Repair # 07597
A _____

SEWAGE DISPOSAL SYSTEM

MARYLAND STATE DEPARTMENT OF HEALTH

A SEWAGE DISPOSAL SYSTEM LOCATED AT 2 Douglas Rd - 2nd house
on left from Manhattansville Rd - between Routes 70 and 147

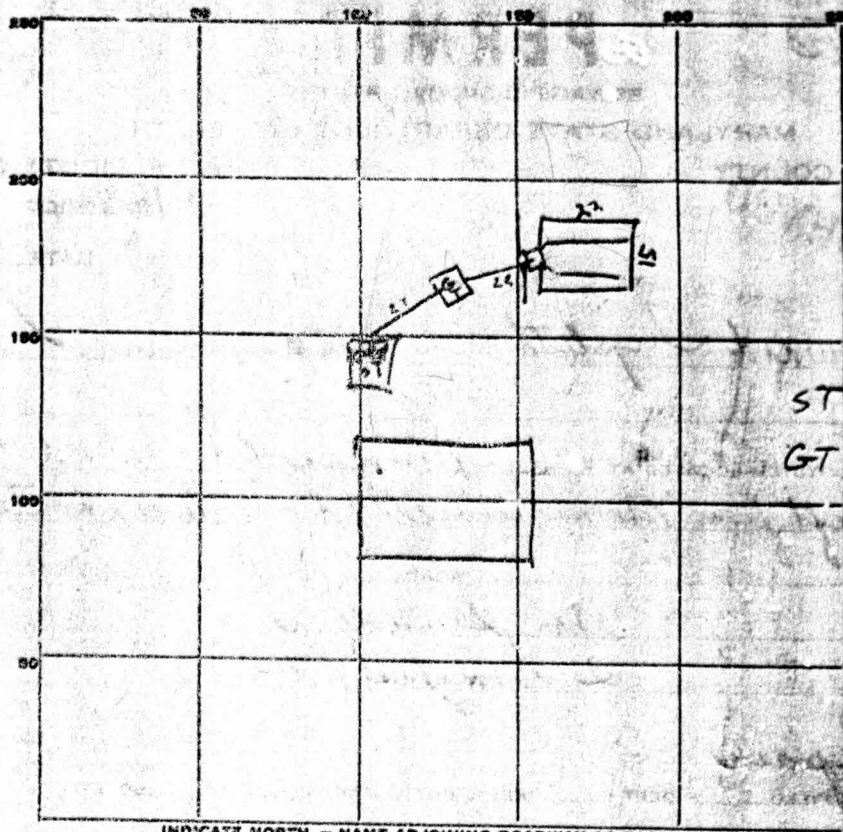
REMARKS Good soil in bed

Only 2 ft rock in bed. No rock over top of pipes. Unnecessary Grease Trap installed downstream from tank. However this is good enough for repair job.
